Morecambe and Morgan Transmission Assets

Examining Authority's First Written Questions – Deadline for Submission 7th July 2025

Response of Lancashire County Council

Extract: Manual for Streets Figure 6.18.

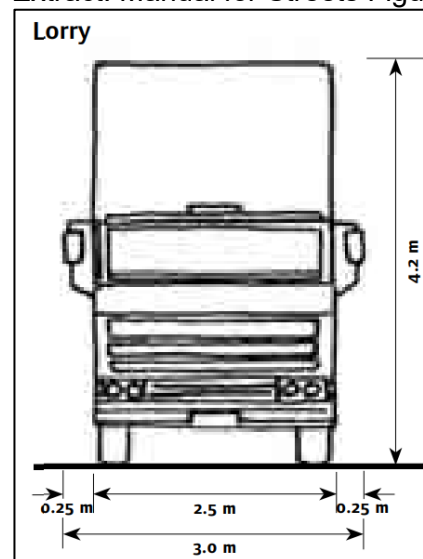
within land controlled by the applicant or the County Council. The current oCTMP only proposes mitigation at highway links that have a carriageway width of less 5.0m.

Whilst the oCTMP proposes some generic mitigation measures, the County Council requires further detail with regards to the number of HGV movements in and out of each access and need a refinement of the Traffic Management measures/mitigation that has regard to each location/pinch point/corridor.

The deliverability and whether the principles of the generic mitigation can operate at specific locations is yet to be presented.

The County Council are willing to consider mitigation proposals, but the principles of the mitigation measures must be demonstrated to be deliverable and operational for each specific highway link, as each link has its own unique constraints.
